PLANNING COMMISSION AGENDA  
CITY OF PRAIRIE VILLAGE  
TUESDAY, NOVEMBER 1, 2016  
7700 MISSION ROAD  
7:00 P.M.

# STAFF REPORT

**Application:** PC 2016-126

**Property Address:** 5300 W. 86<sup>th</sup> Street, Briarwood Elementary School

**M.1**

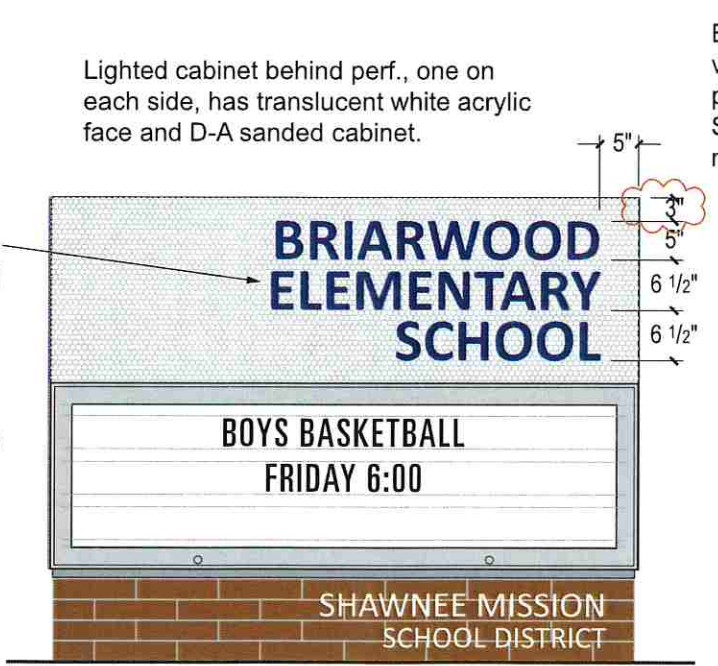
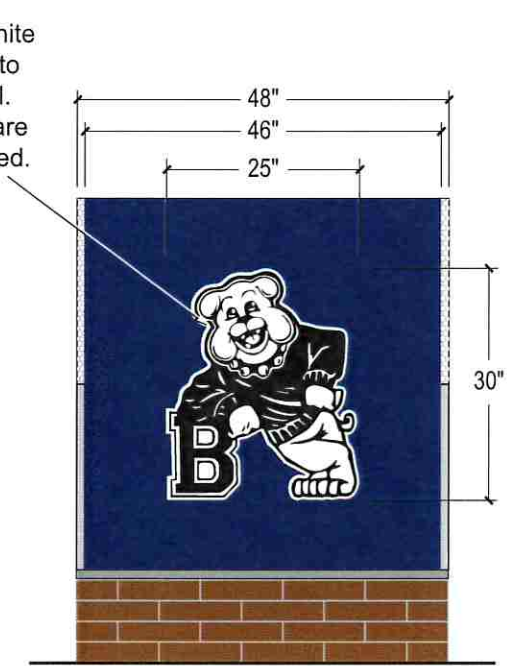
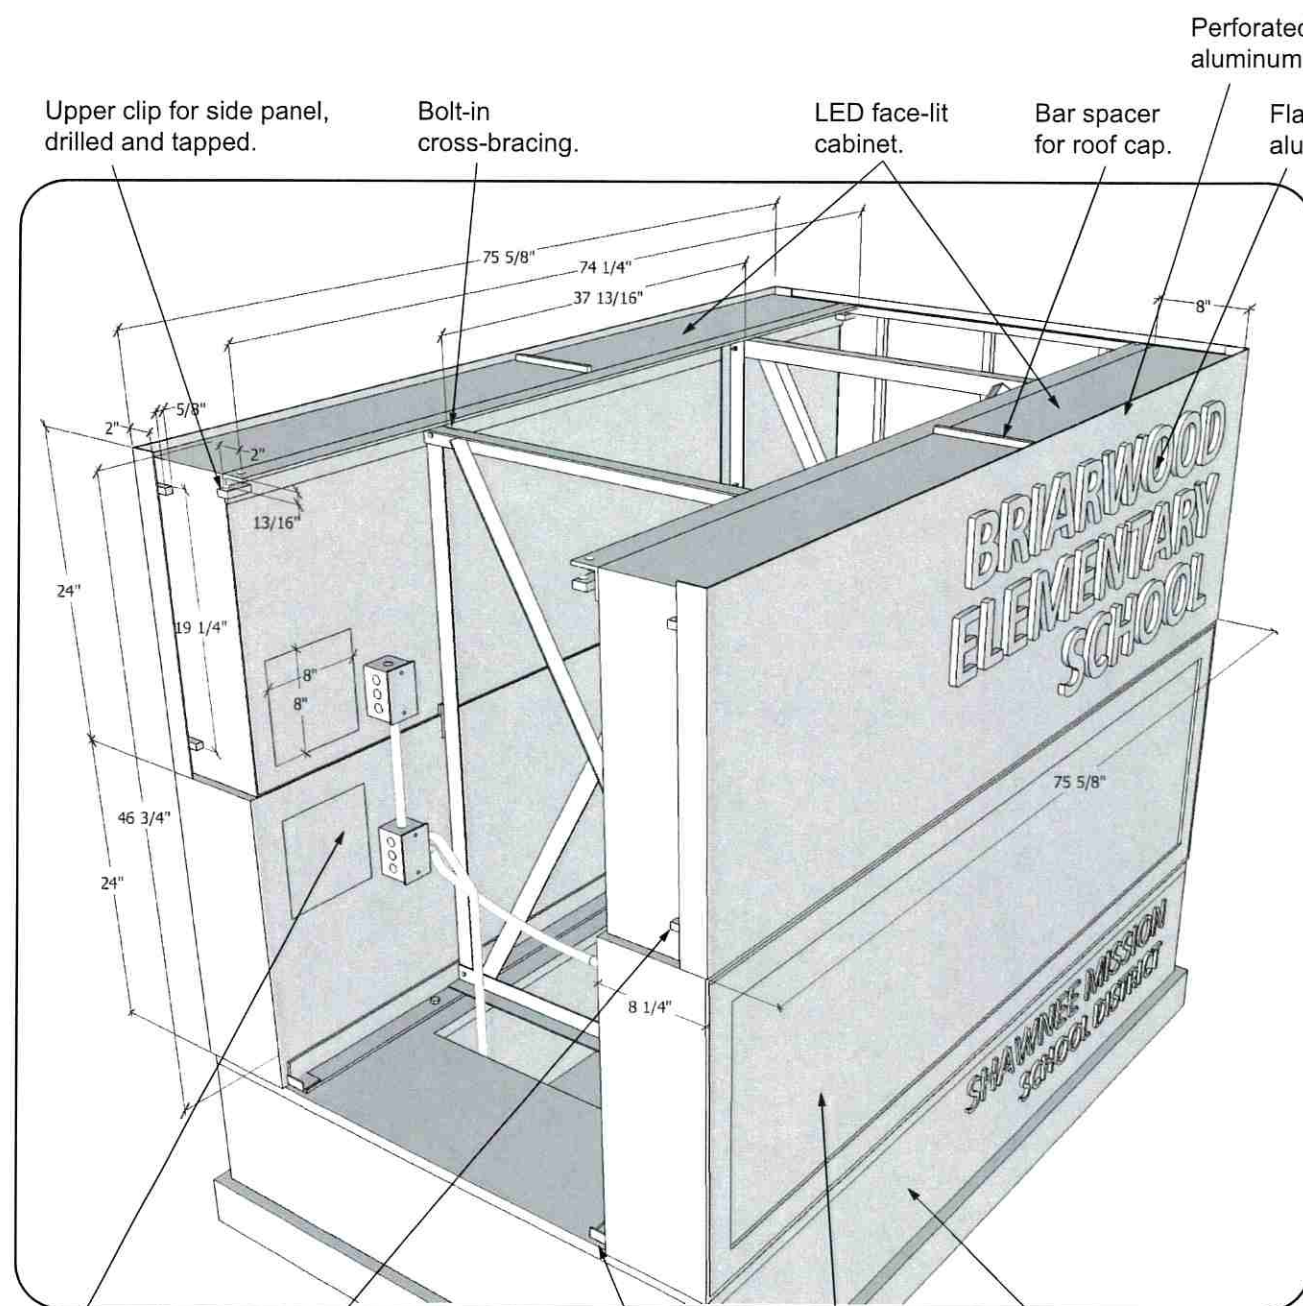
The proposed sign presents some interpretation issues on the sign area. Section 19.48.015.N. Sign Area Calculations states the following for monument signs – “The area shall include the sign panel but not the sign base on which it is mounted or the structural elements or frames that form the perimeter of the panel. The following are specific to this application:

- The area of the sign panel is 25.25 square feet. (20 square feet is the generally applicable limit, and was the size approved in May 2015 for Shawnee Mission East)
- The actual sign area (text and changeable copy area) is slightly under 20 square feet.
- The sign includes a 4' x 4' school logo on the side. (a similar design was approved in July 2015 for Shawnee Mission East.)
- The brick base of the sign – which is to be excluded from sign area per the ordinance section above – includes sign text. (This text was included in the second calculation above where the text area was shown to be slightly below 20 square feet.)
- The proposed base material is not specified by appears to be the same or similar materials and colors as proposed for the school building.

Although this sign is larger than the size for monument signs generally applicable for the area if you measured just the sign panel, the text area is compliant with the sign area limit. Further, the site is 9.1 acres and to overall structure (base and sign panel) are within scale of this sized site.

1. The location of the sign be specifically verified to be at least 3' from all property lines and be verified by Public Works to demonstrate no other site issues associated with the location and drive entrance.
2. The location and siting be integrated with the proposed landscape plan approved with staff comments.

Monument Sign Landscape

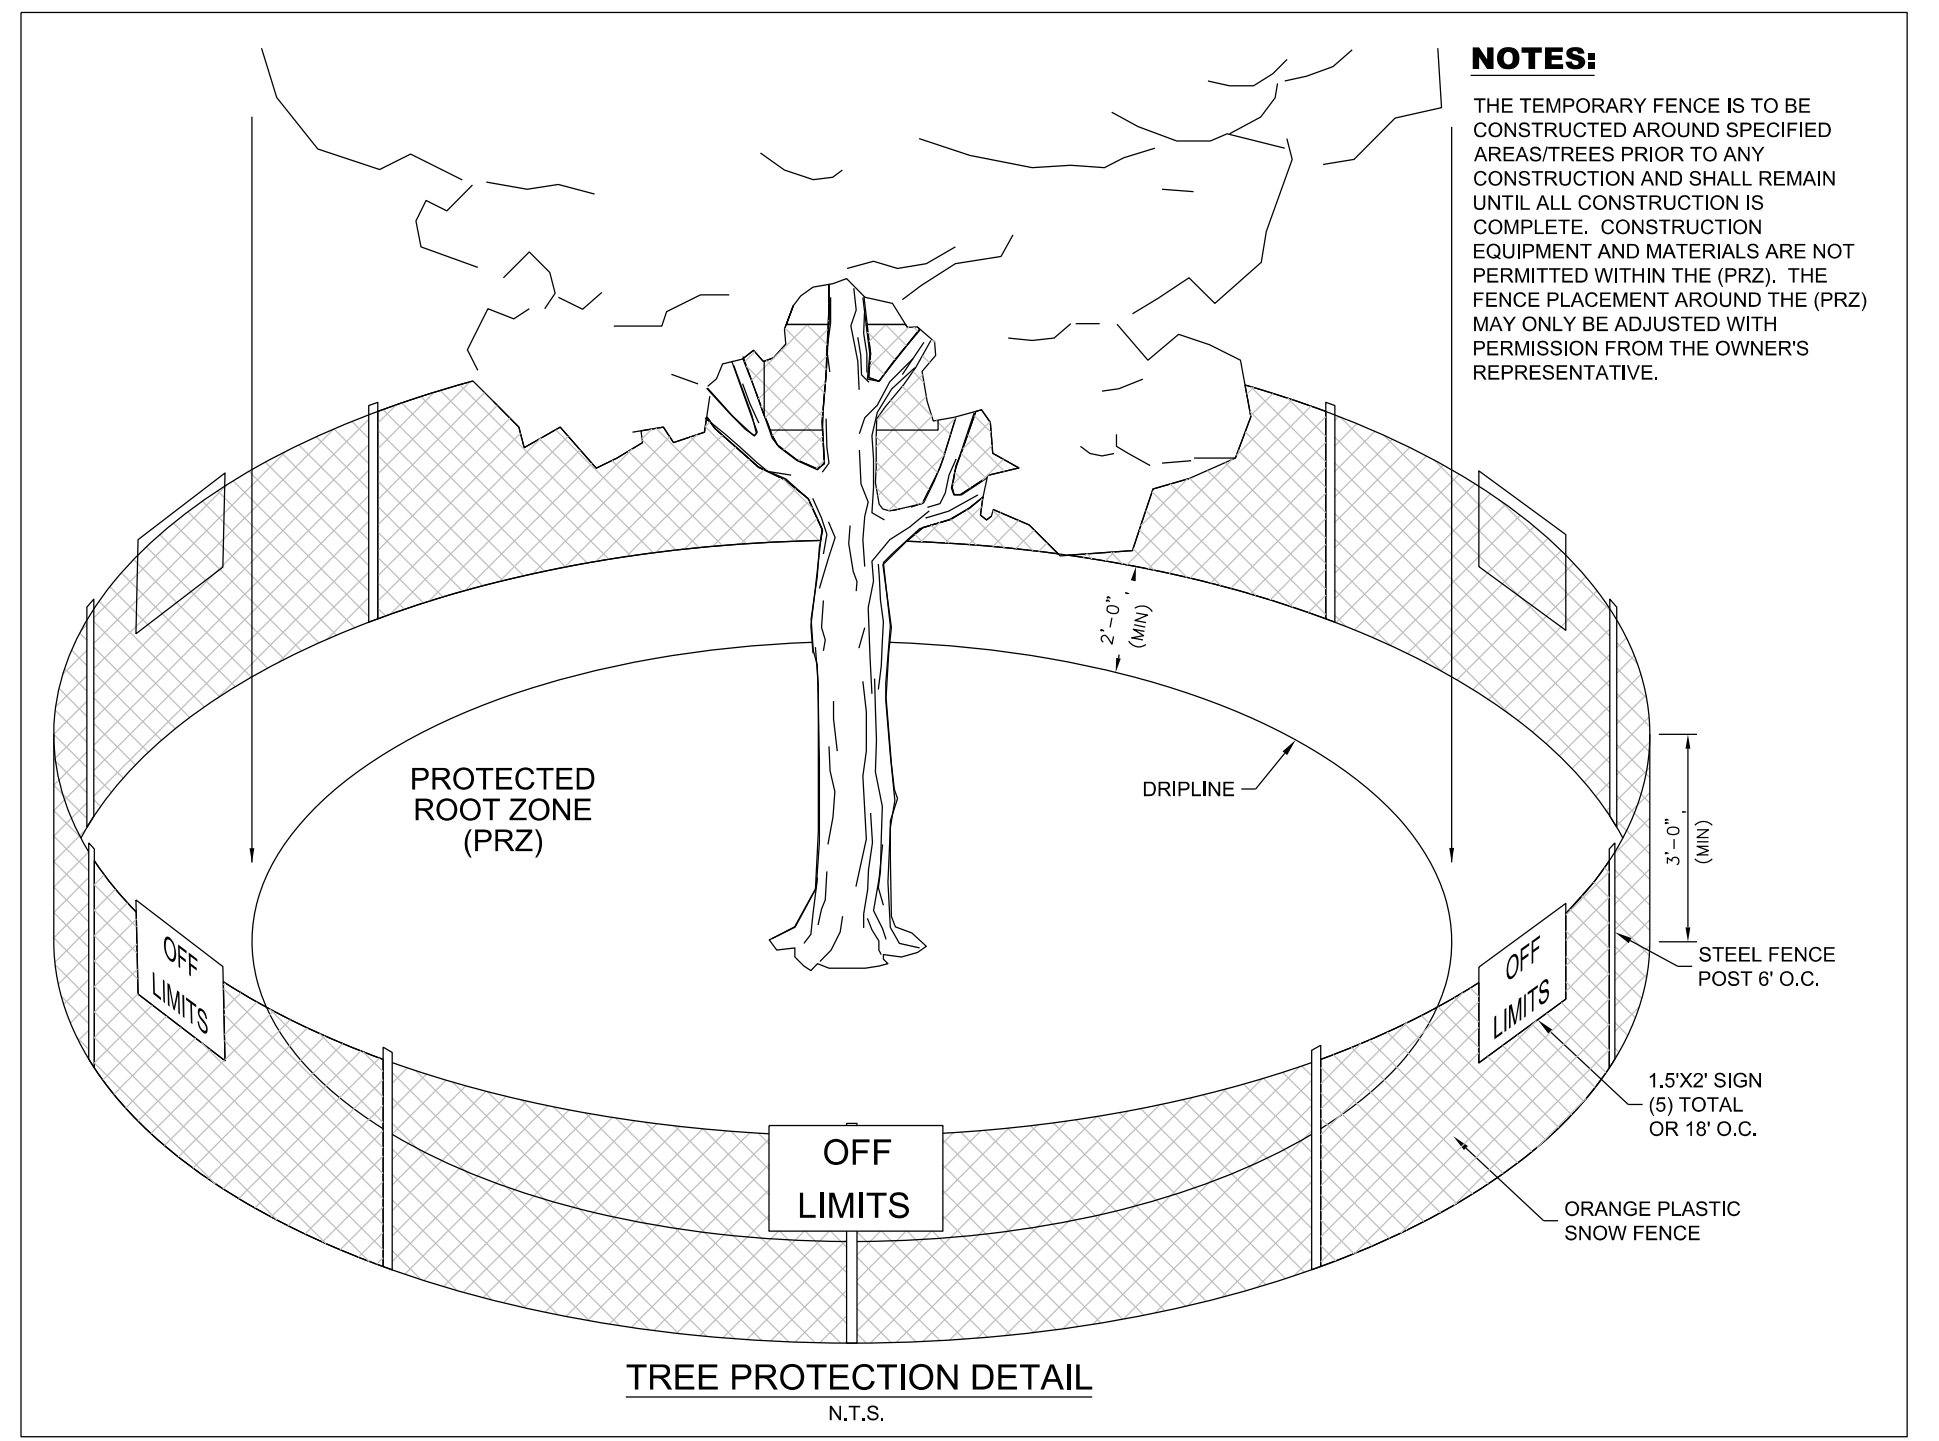
Jonathan Birkel questioned the proposed landscape plan, noting the proposed size and location of plantings would impact the visibility of the proposed lettering as shown on the Shawnee Mission South sign photograph submitted by the applicant. Mr. Brewster replied that a landscape plan for the entire project was completed and presented to staff for review a few weeks ago. He noted that he will consider Mr. Birkel's comments in the evaluation of the plan. He noted the code does not necessarily require landscaping at the base of the sign; the sign could be placed within a landscaped island.

# ELEVATIONS

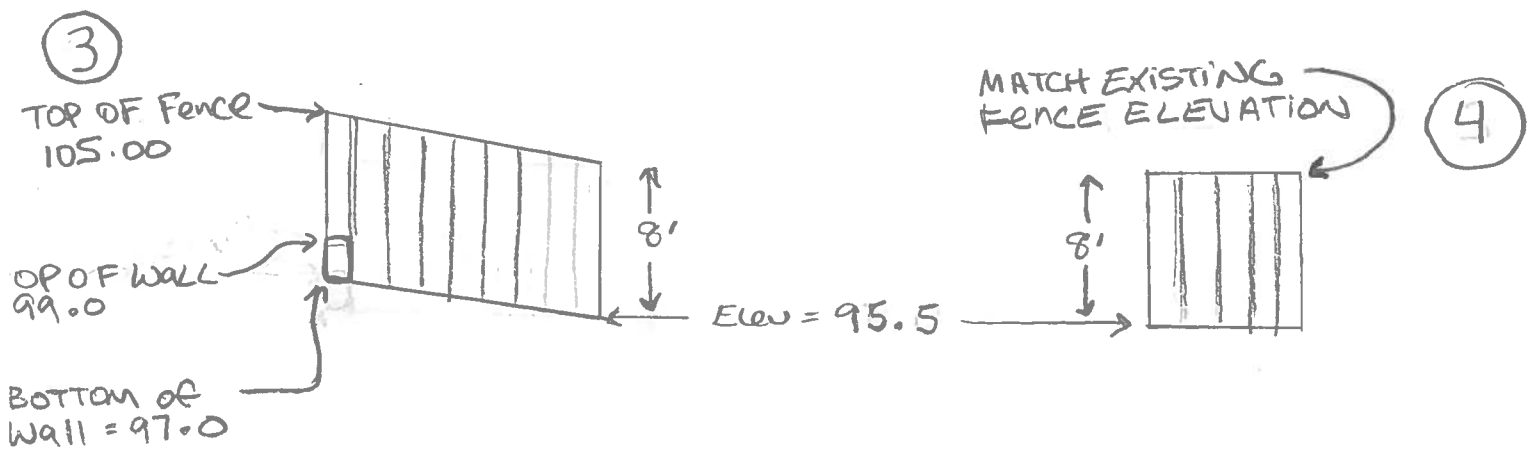
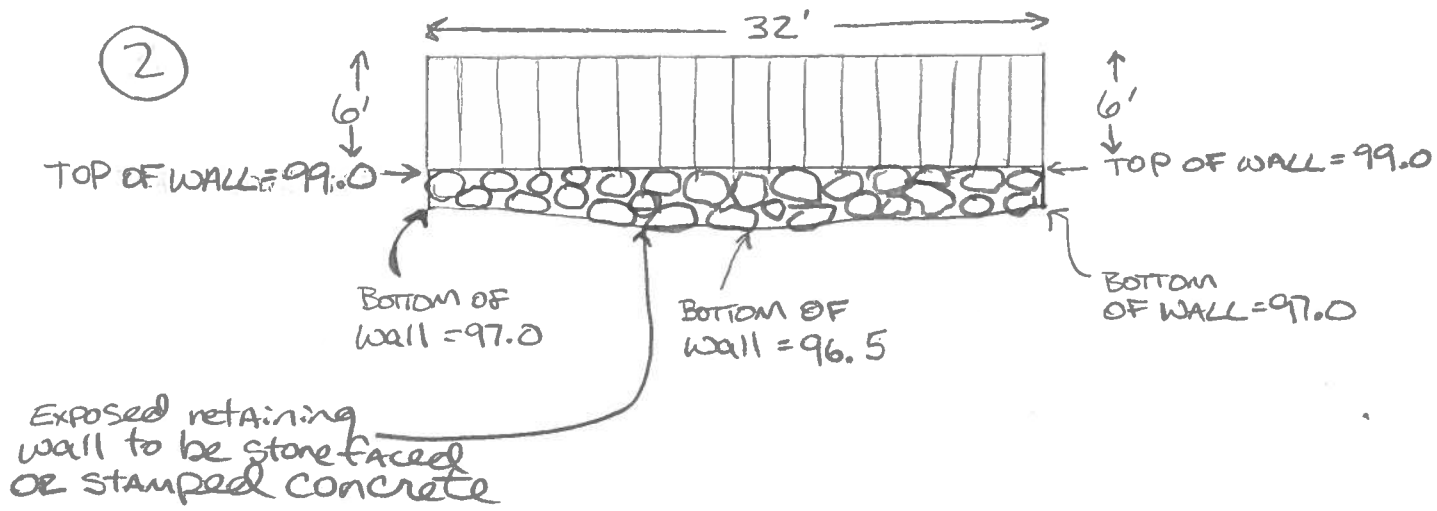
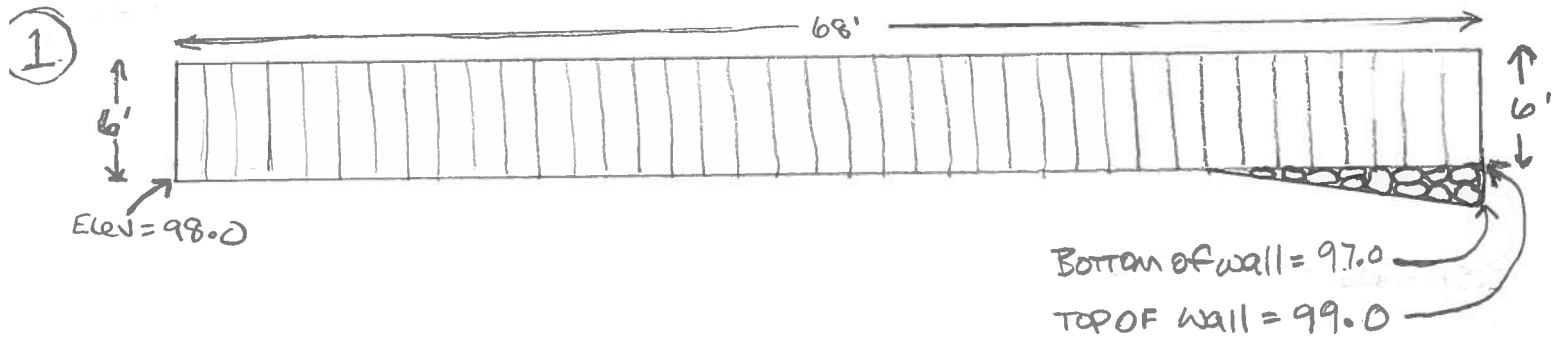
- Elevation 4 – an approximately 6' section of fence that will be replace the existing fence on the north lot line. This section is proposed to be 8' high to tie in with the neighbor's fence, which is approximately 8' high.
- Elevation 3 – an approximately 15' section of fence that will replace the existing fence line (east line) from the proposed new fence and retaining wall, and tie into the existing fence on the north lot line. This section is proposed to be 8' high to tie in with the 6' high fence that is sitting on top of the 2' to 2.5' retaining wall proposed for the new fence.

Planning staff recommends that the proposed site plan for a fence with a portion of the fence height exceeding 6' be approved subject to the following conditions:

1. At the time of building permits, public works shall review a grading plan and construction plan for the retaining wall proposed at the northeast portion of the fence area.
